A303 Amesbury to Berwick Down

Deadline 7
8.45 - Errata Report

ERRATA Report

Regulation Number:	Regulation 5(2)(q)
Planning Inspectorate Scheme Reference	TR010025
Application Document Reference	8.45
Author:	A303 Amesbury to Berwick Down Project Team, Highways England

Drawing Title: FIGURE 13.3A PROPOSED PUBLIC RIGHTS OF WAY

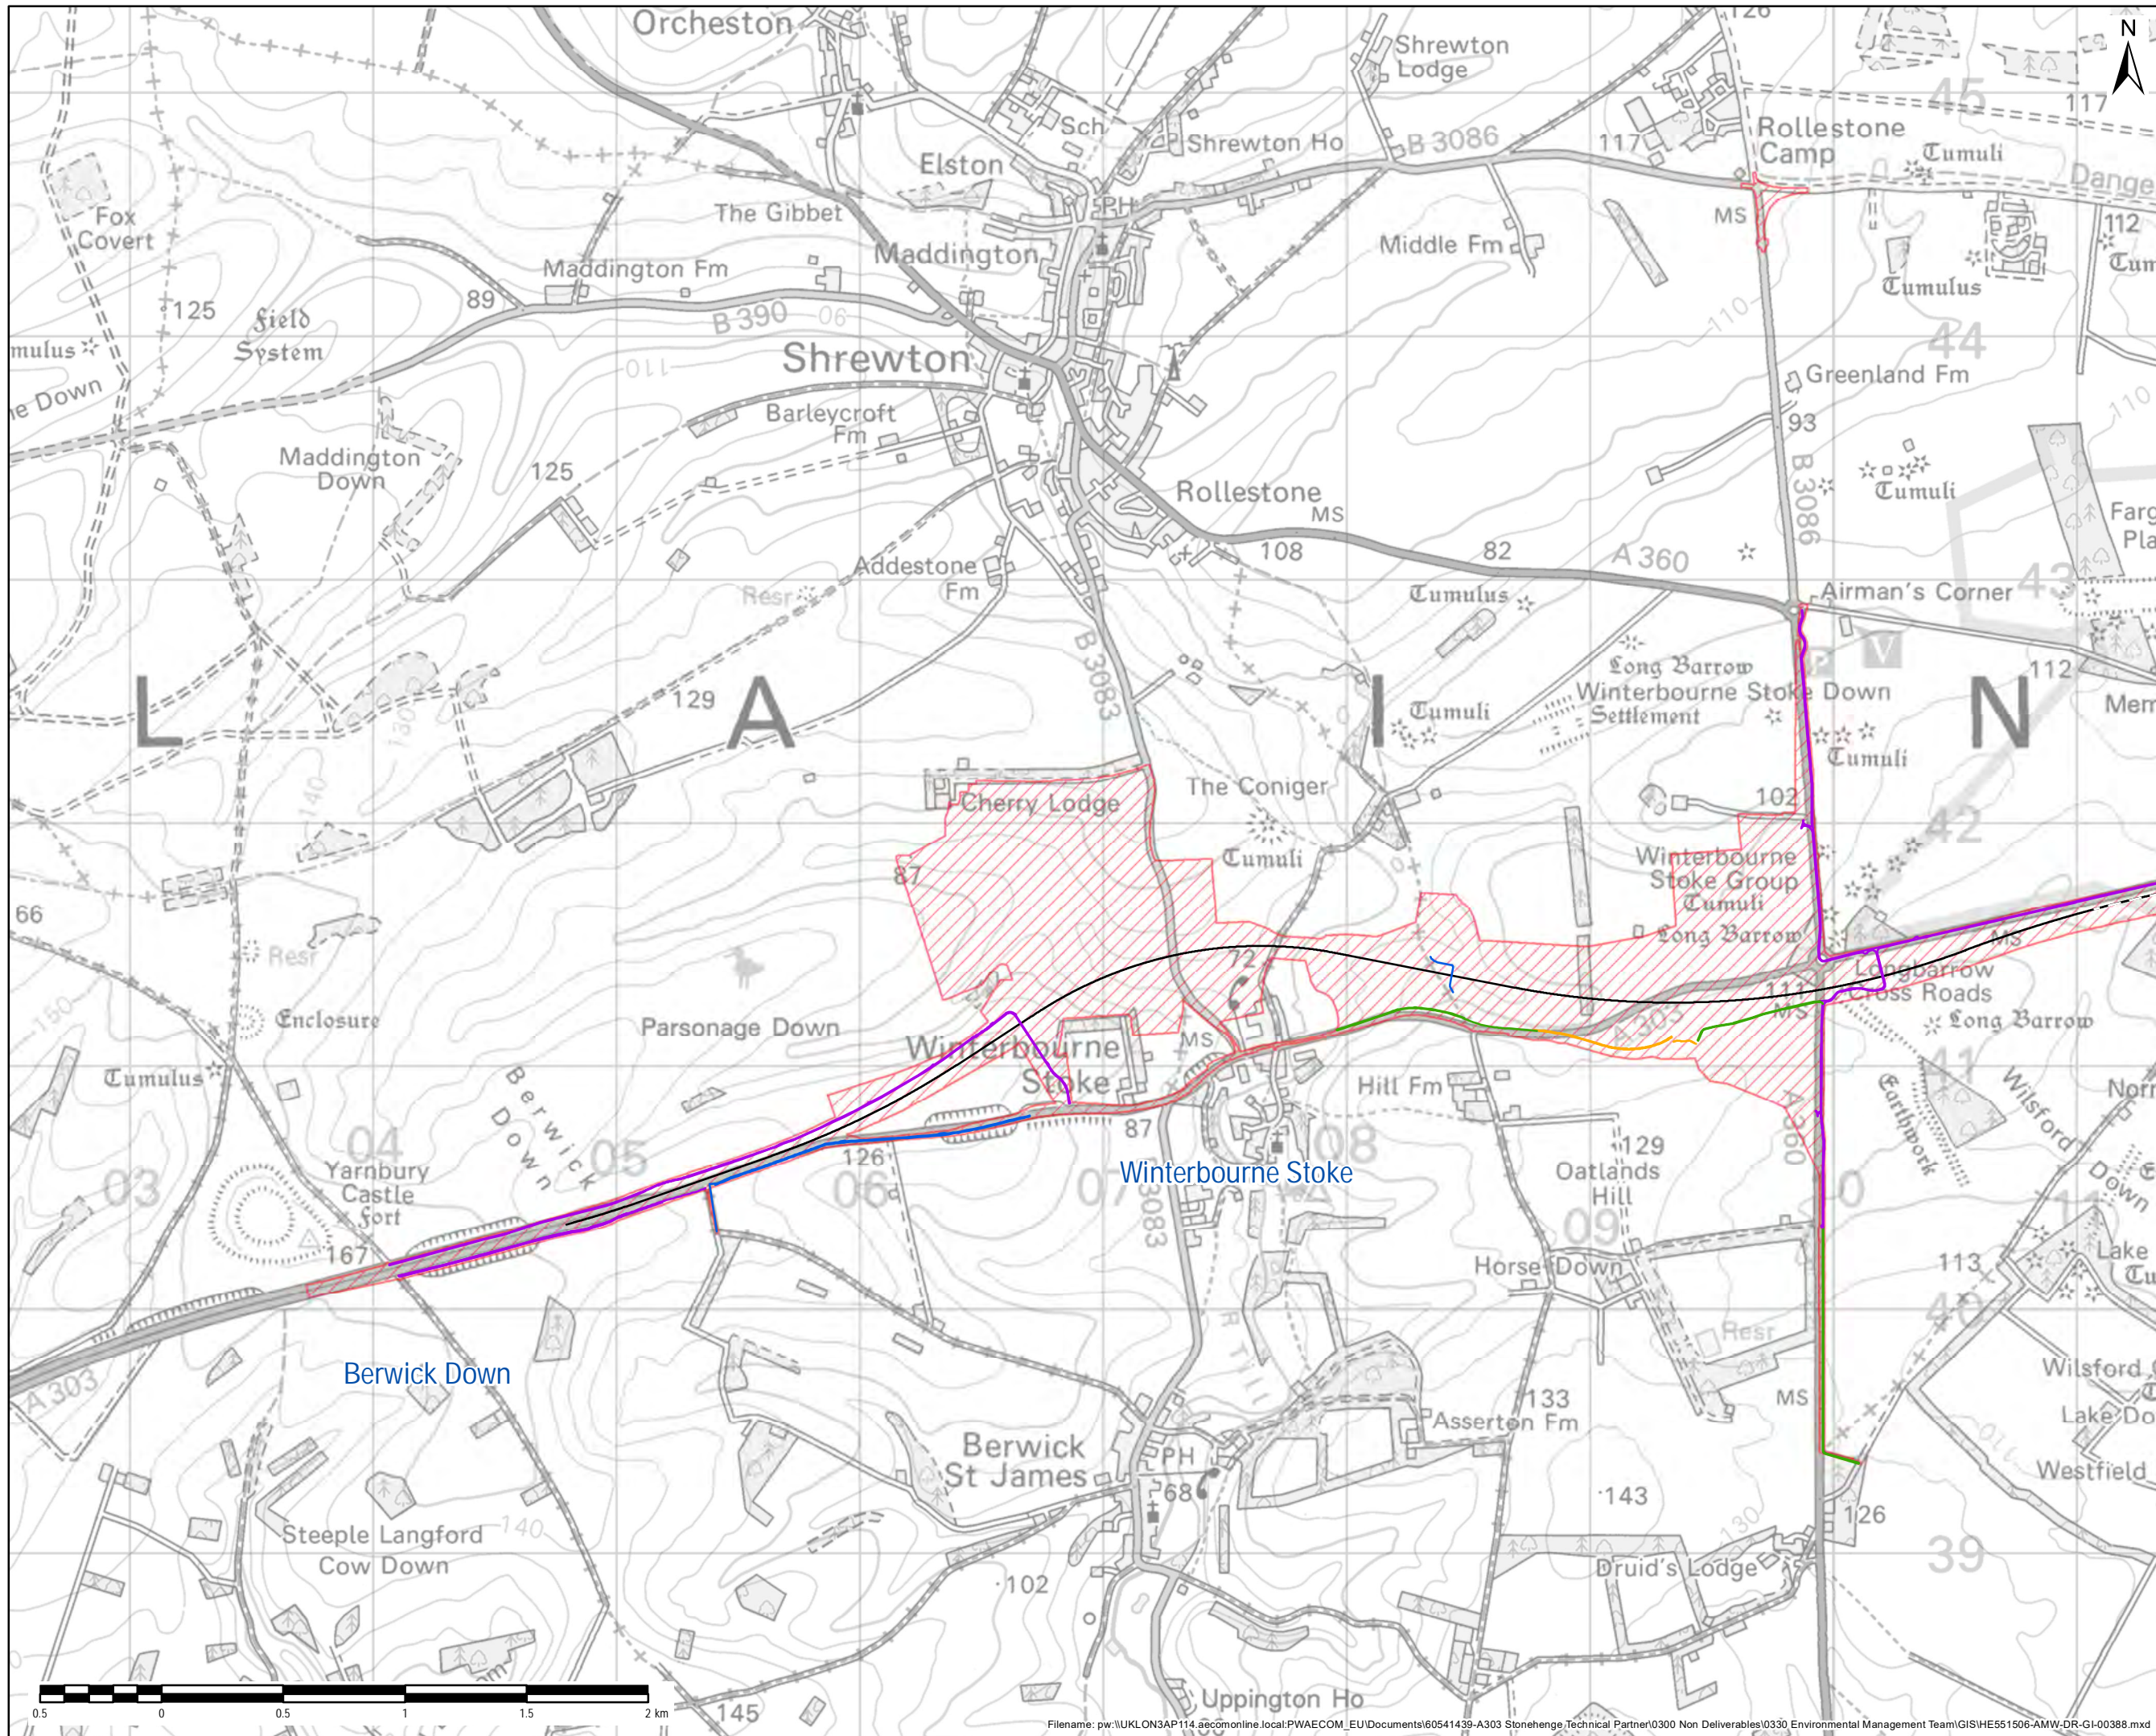
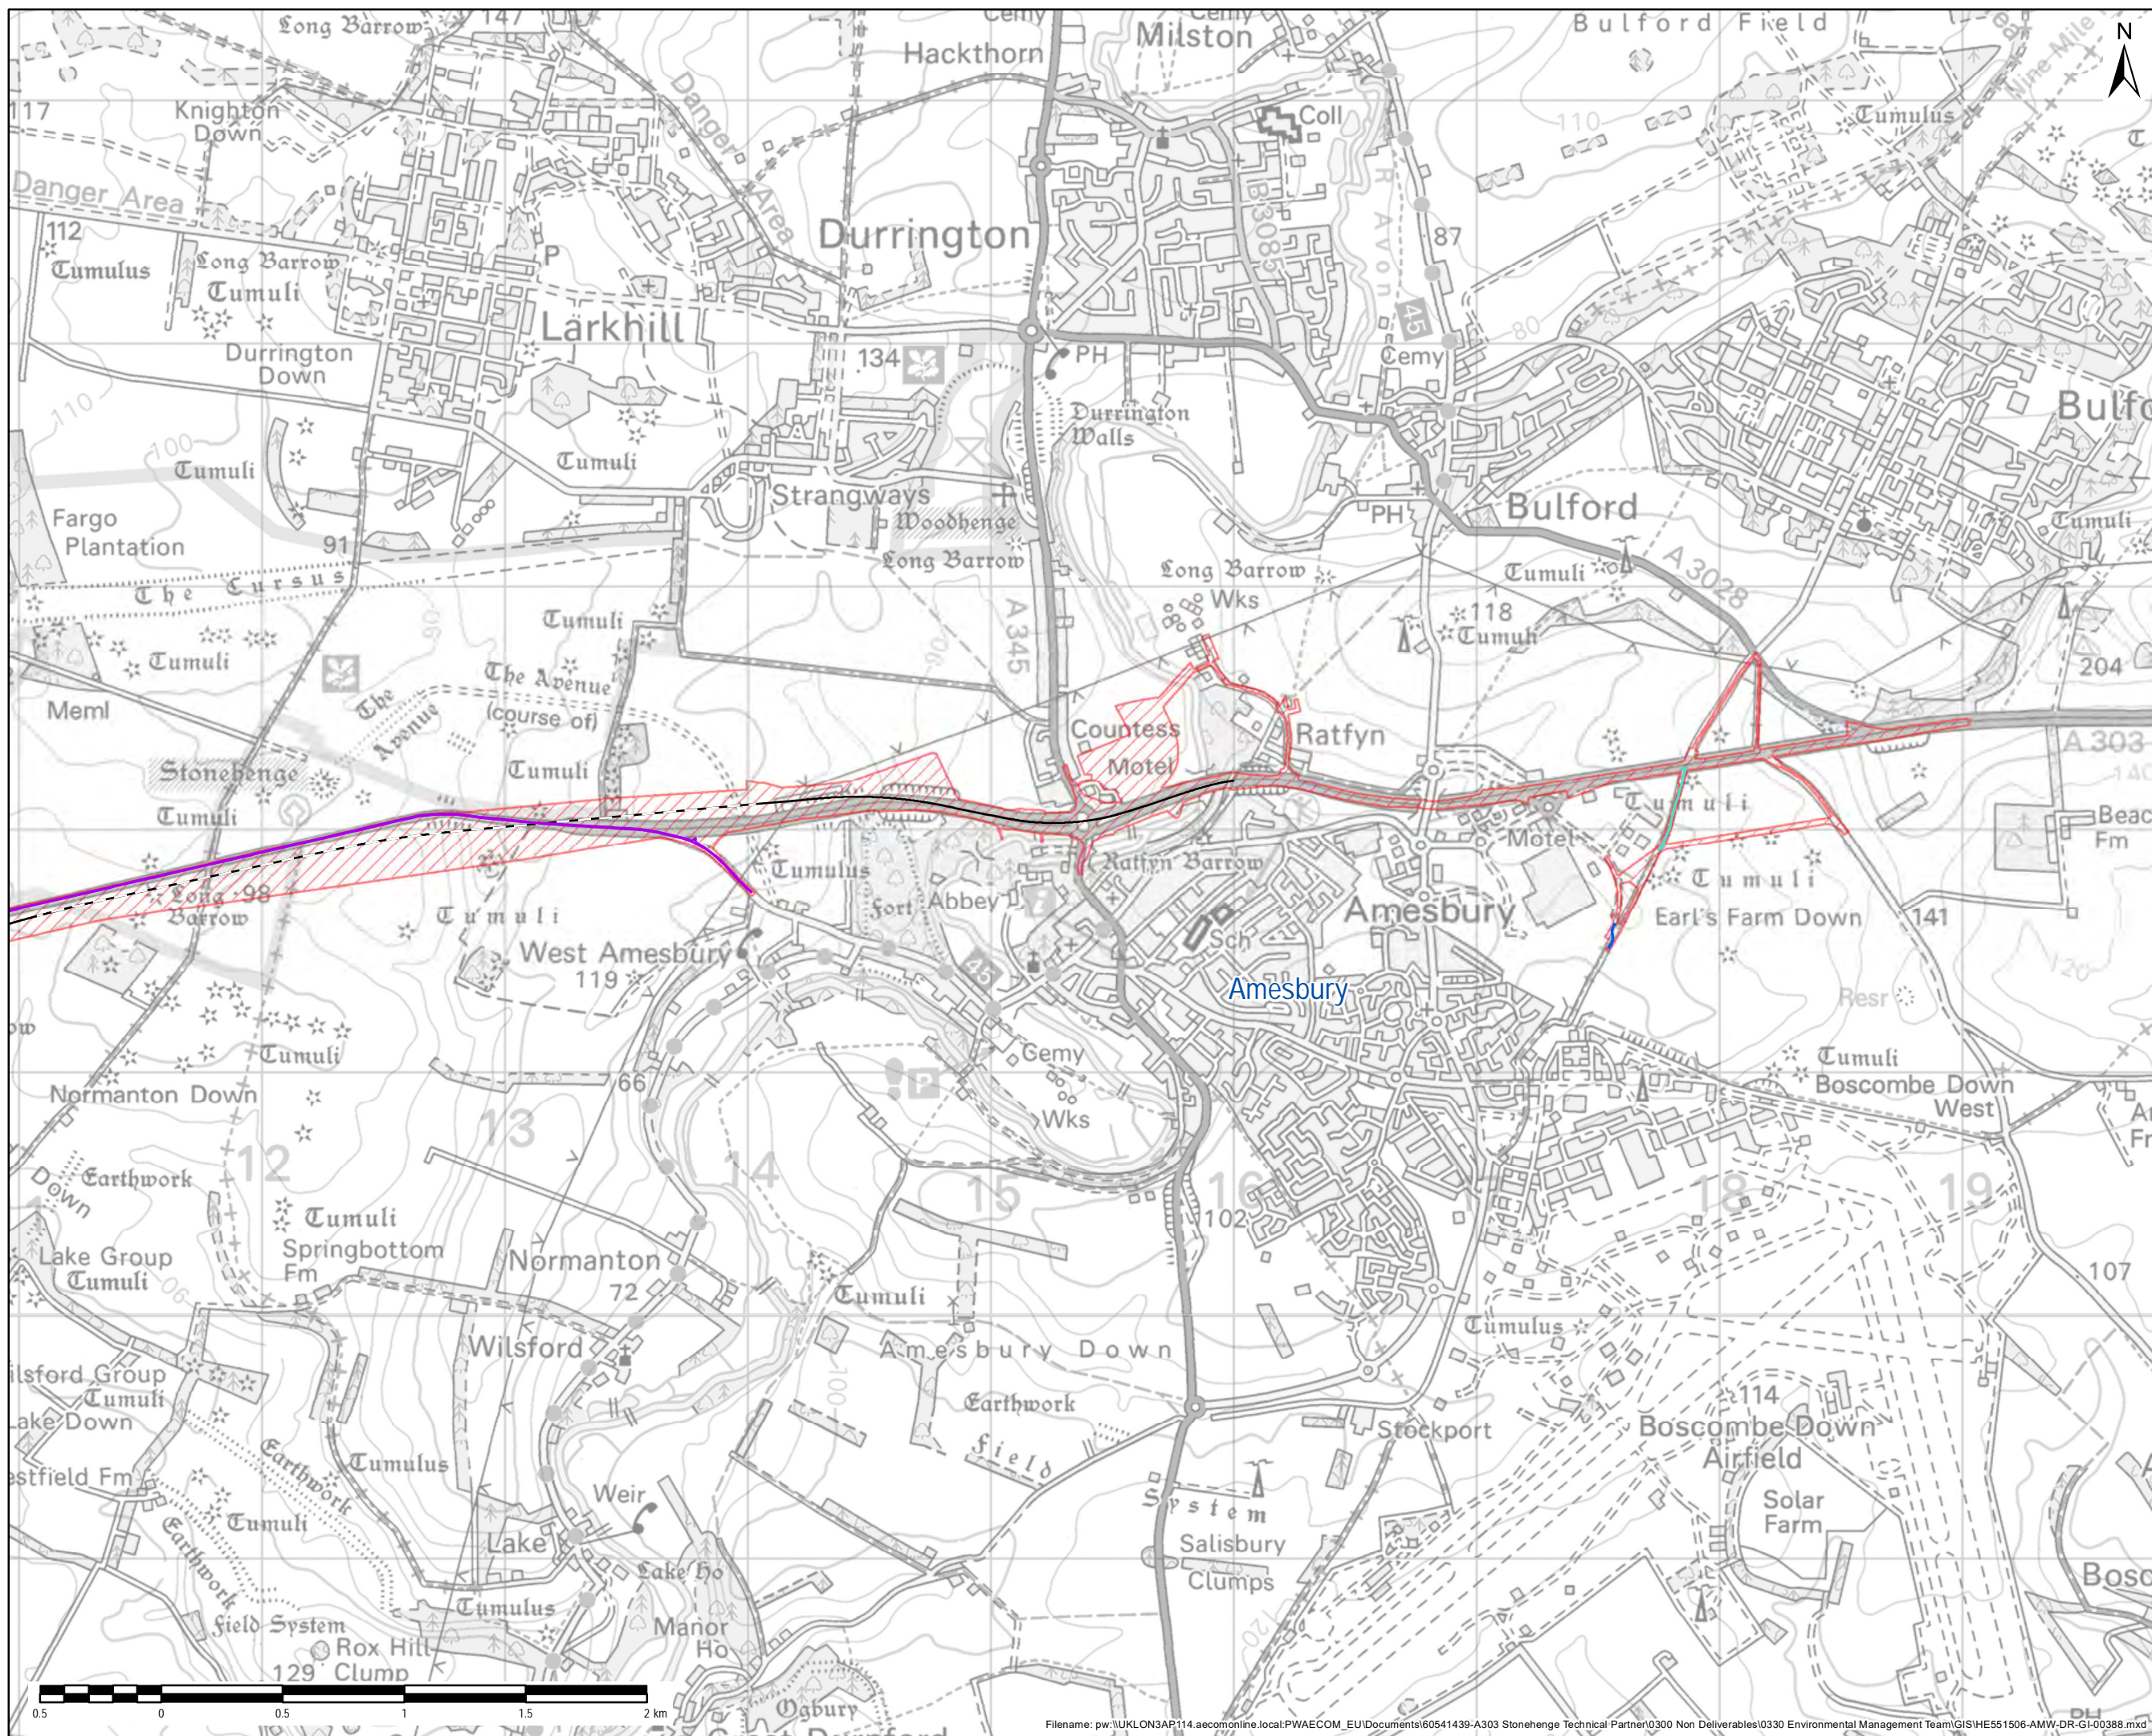
Document no.	Document name	Section and Paragraph Reference	Nature of Erratum and Explanation	Replacement Text
APP-180	ES Chapter 13	Figure 13.2	Error in Figure title	<p>The title of the Figure should be amended as shown:</p> <p>“FIGURE 13.2 EXISTING NMU ROUTES PUBLIC RIGHTS OF WAY”.</p> <p>The corrected figure is provided in Appendix A of this Report.</p>
APP-181	ES Chapter 13	Figure 13.3 A and B	Error in Figures	<p>The title of the Figure should be amended as shown: “FIGURE 13.3A EXISTING NMU ROUTES PUBLIC RIGHTS OF WAY”.</p> <p>The title of the Figure should be amended as shown: “FIGURE 13.3B EXISTING NMU ROUTES PUBLIC RIGHTS OF WAY”.</p> <p>The following errors as shown within the extracts below have been identified in Figures 13.3A and 13.3B. The corrected figures are provided within Appendix A of this Report. To confirm, these are drafting errors only and do not affect the conclusions of the assessment presented within Chapter 13 of the ES.</p>

Appendix A - Corrected Figure 13.2 and Figure 13.3
